Plymouth South High School
Plymouth, MA
Ai3 Project # - 1308.00

Addendum #4

June 22, 2015

ADD4
SKL005

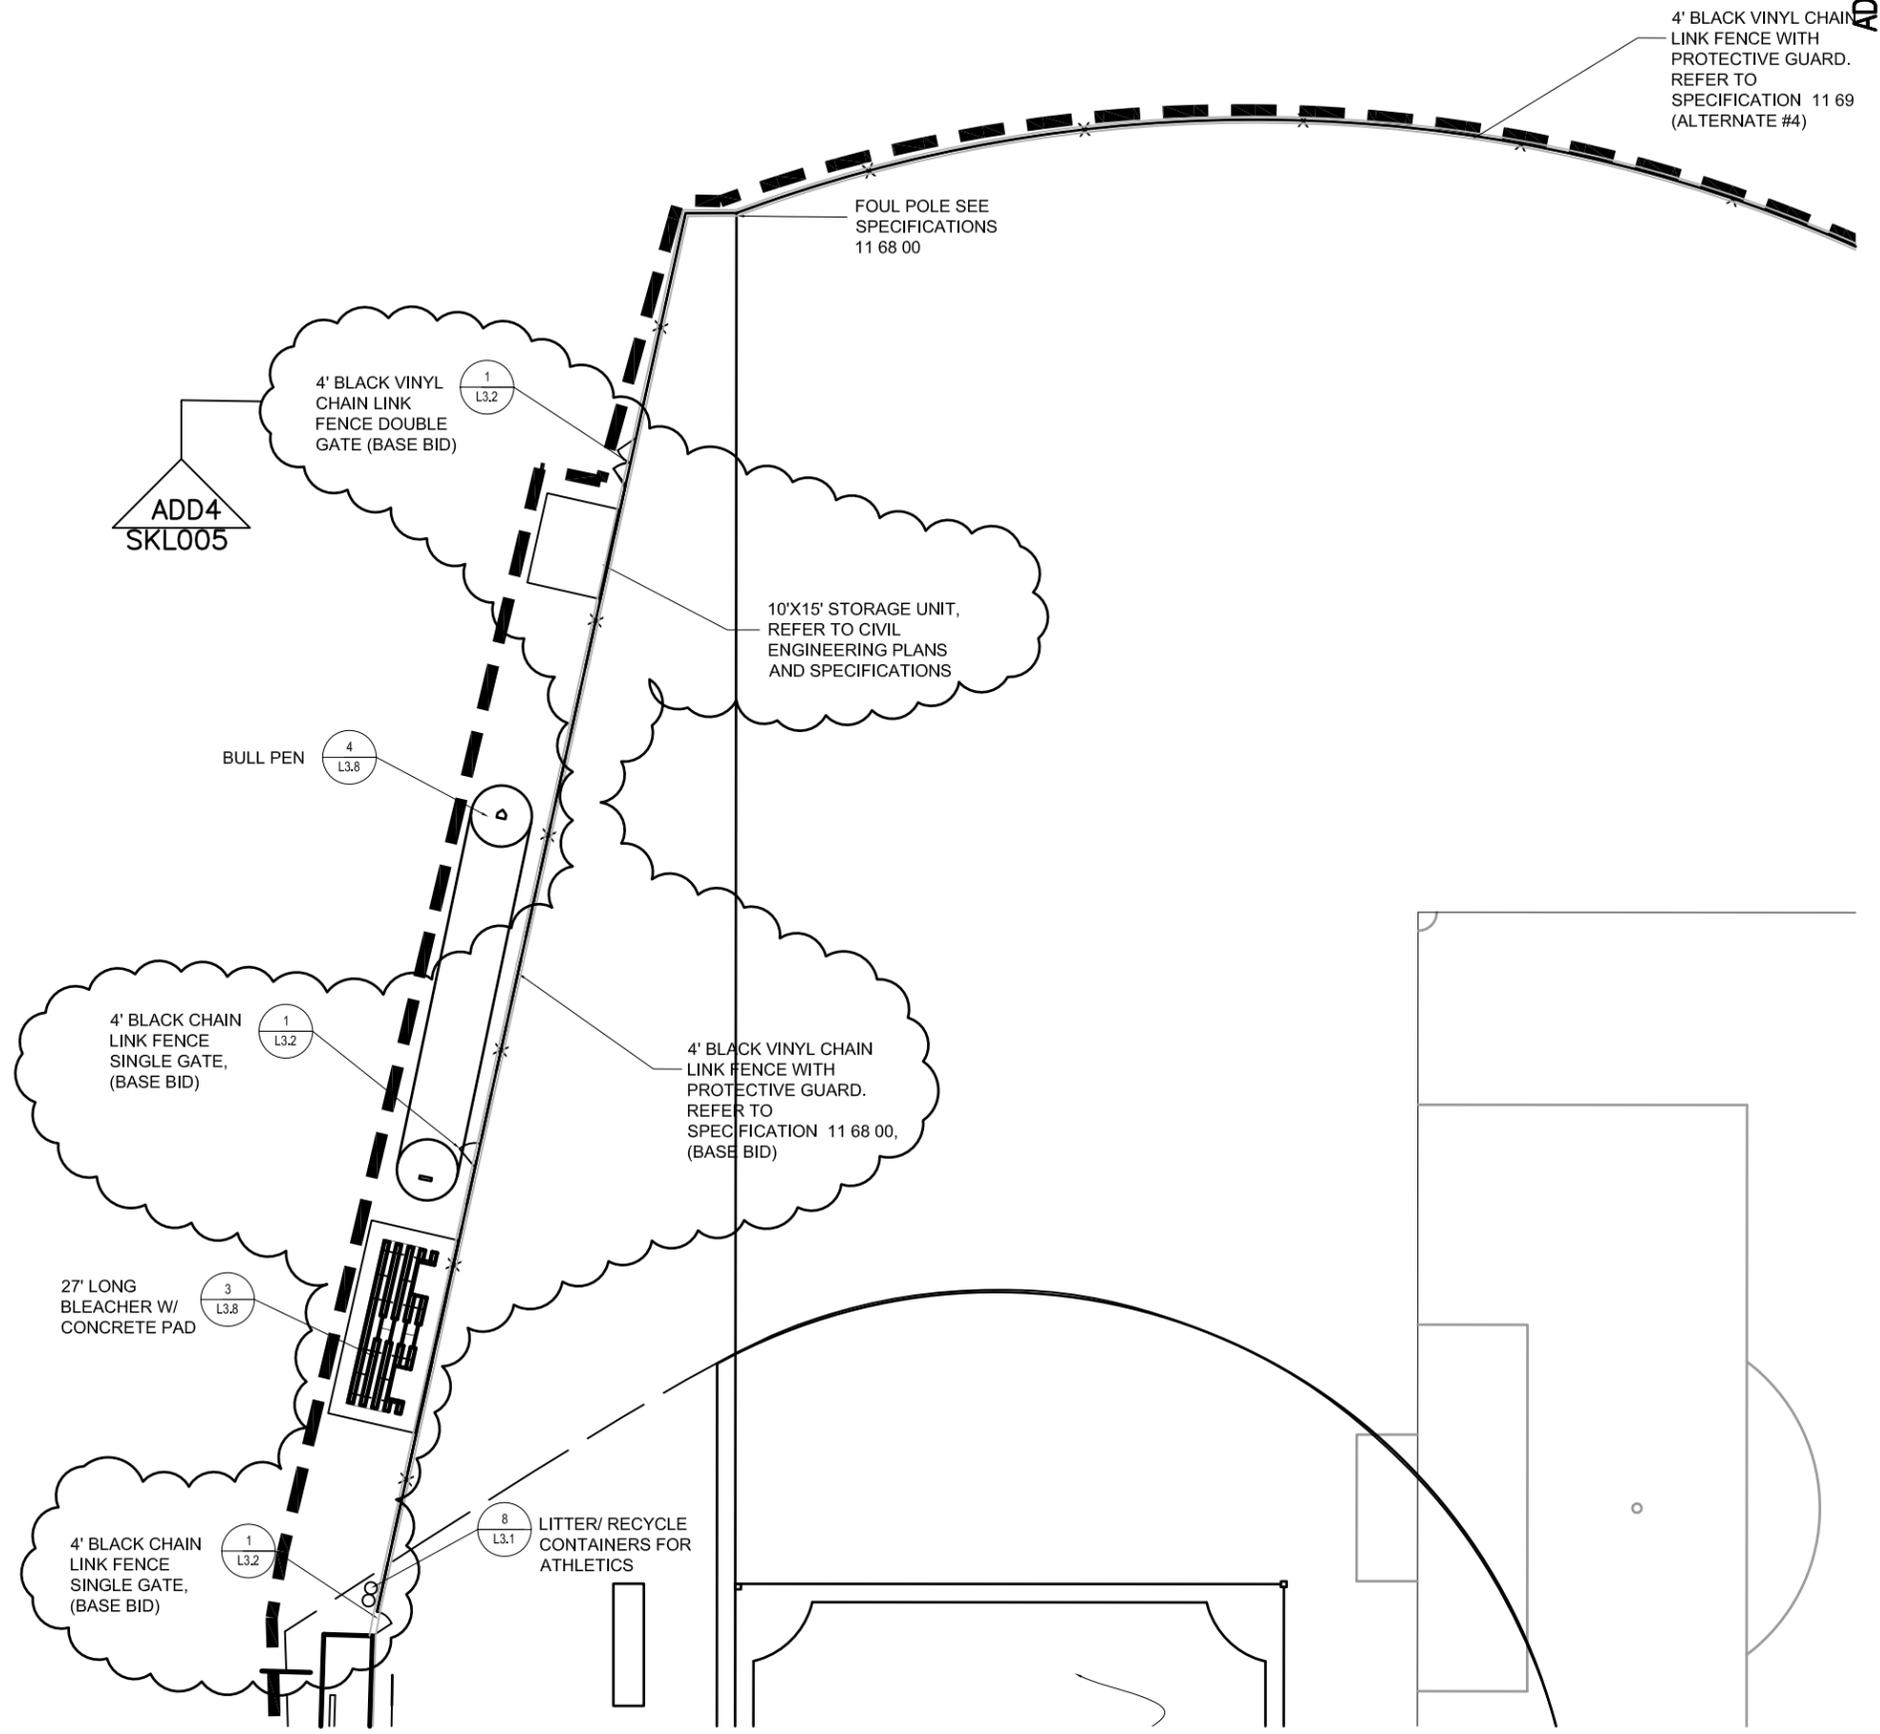
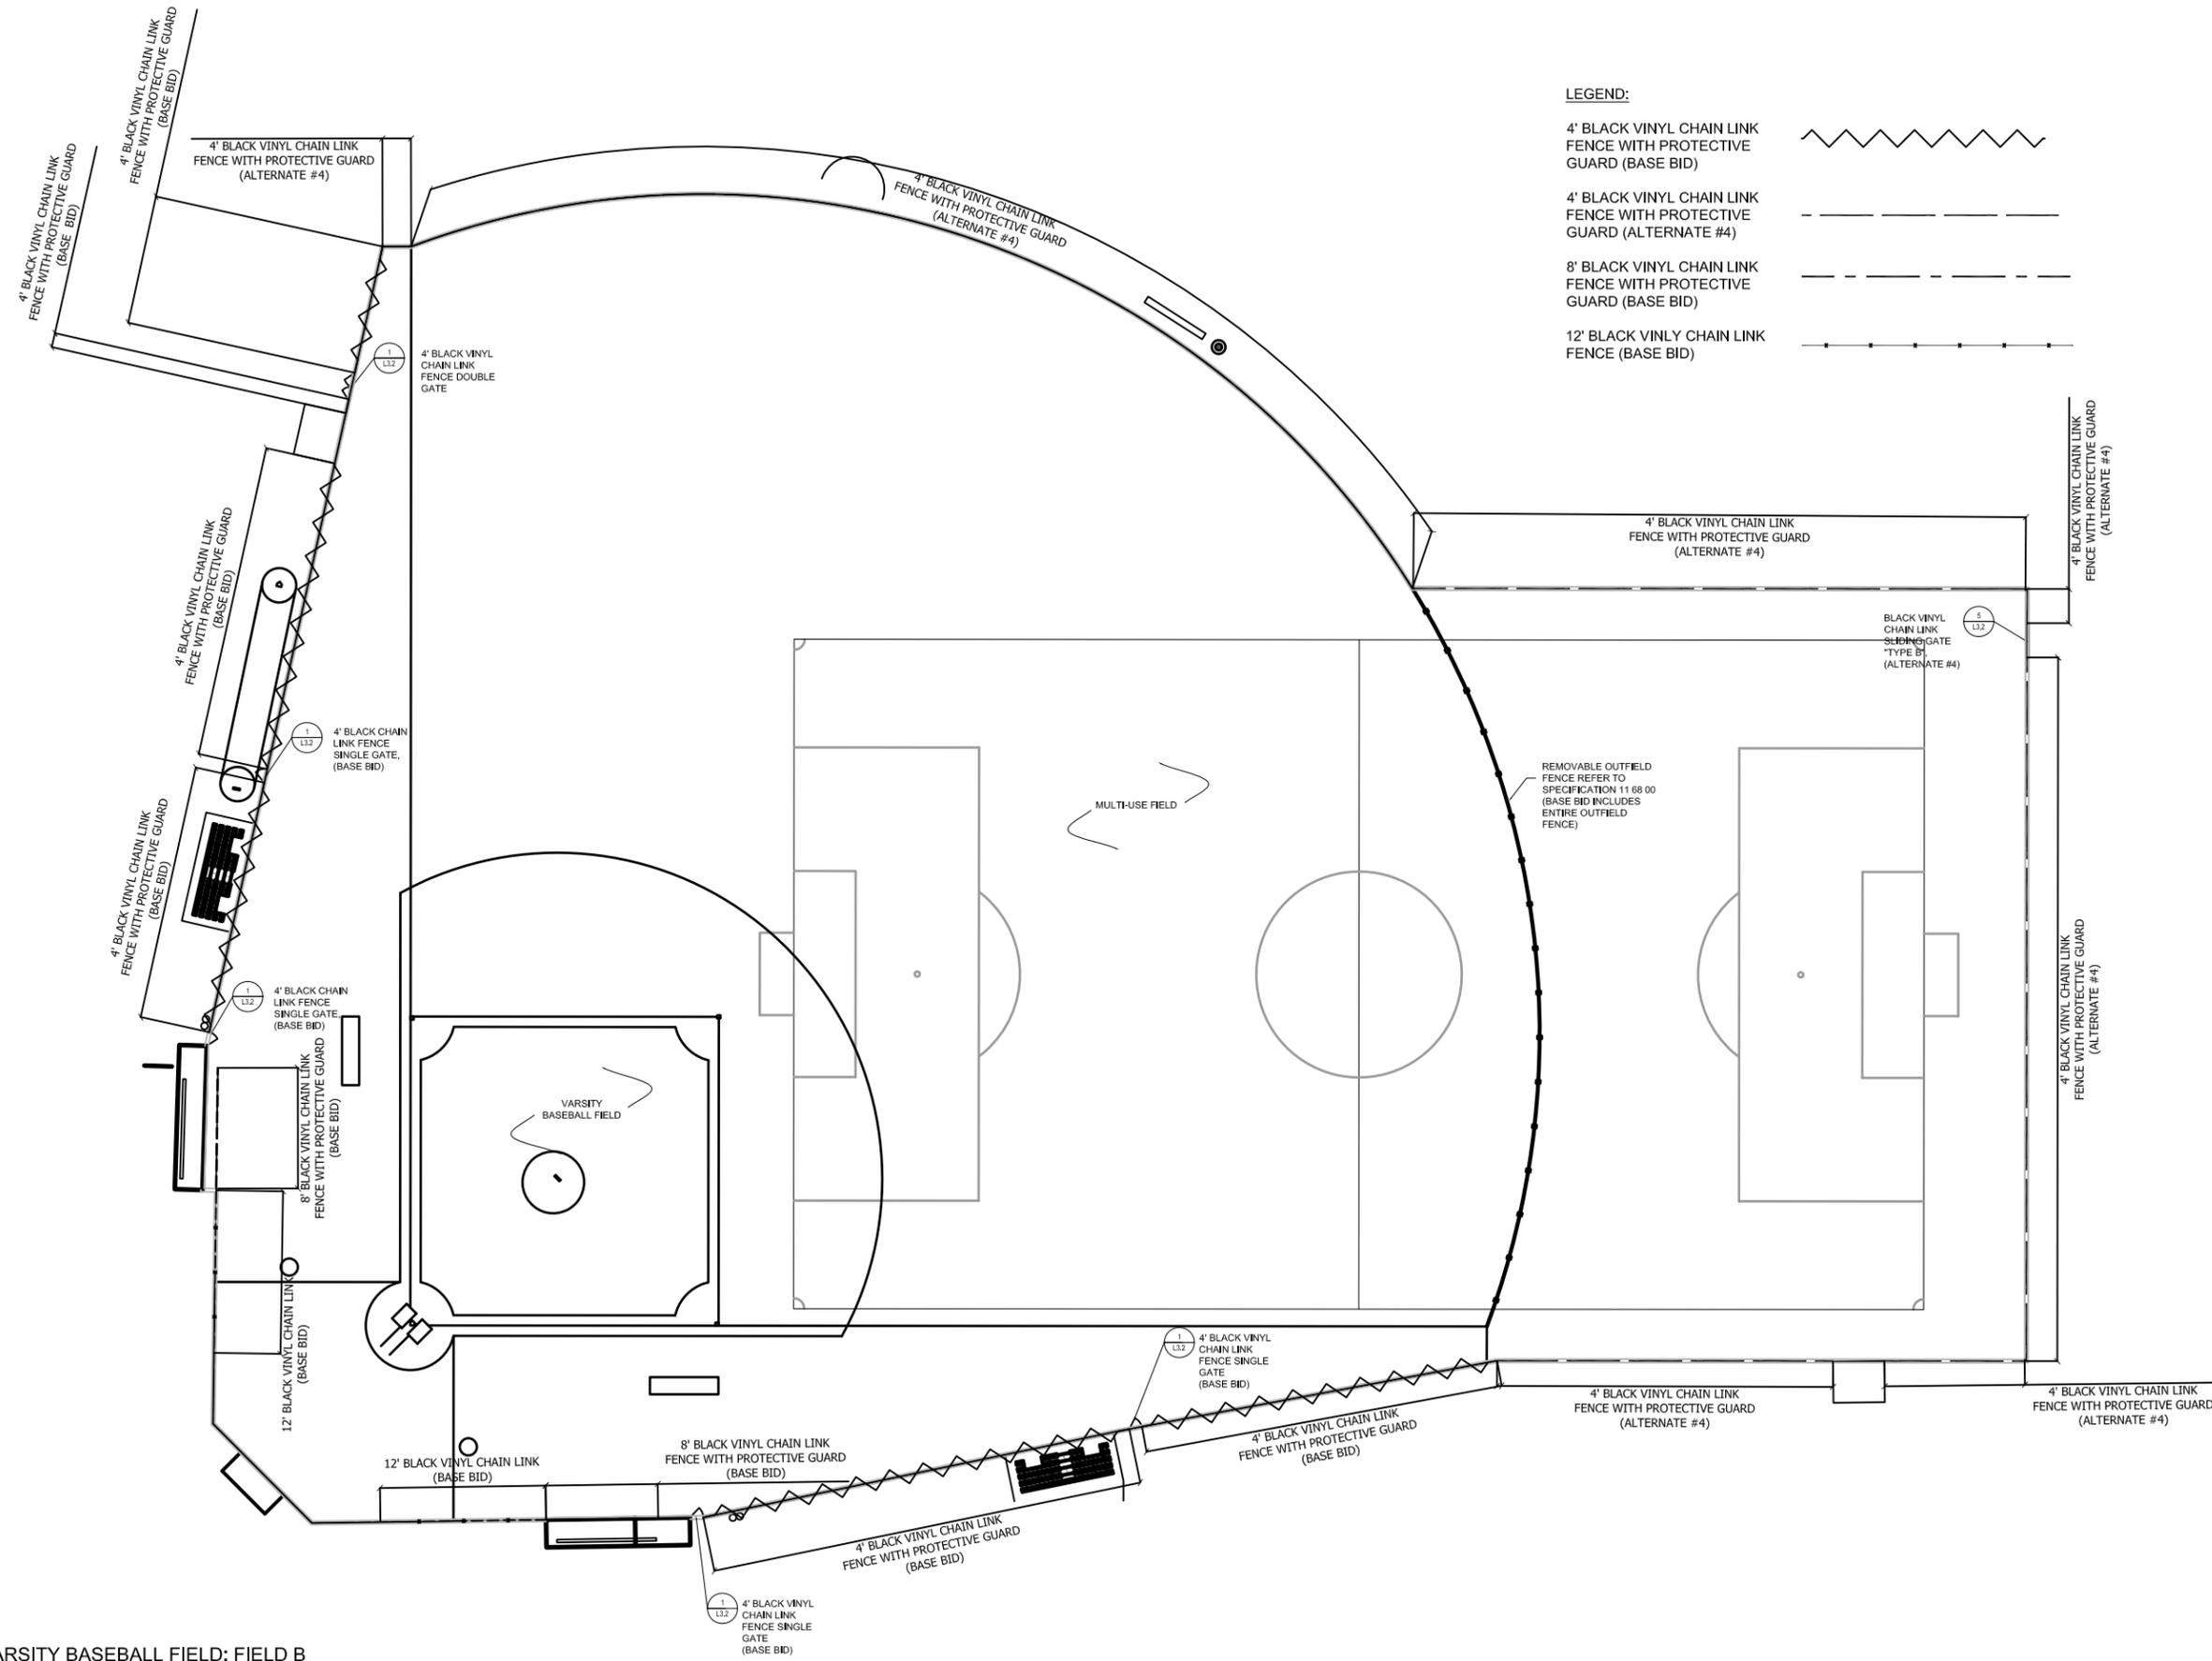
- ADD 4-044 Drawing L3.6 – Landscape Details Plan No. 7
Detail 1 / Varsity Baseball Field: Field B:
REMOVE: "11 69 00" and REPLACE with "11 68 00" on fence call out, per sketch SKL-004 and SKL-005

REVISED all 4' black vinyl chainlink fence with protective guard, 8' black vinyl chain link fence with protective guard, and 12' black vinyl chain link fence along the first base foul line and the third base foul line of the varsity baseball field to be part of the base bid as indicated on SKL-009.
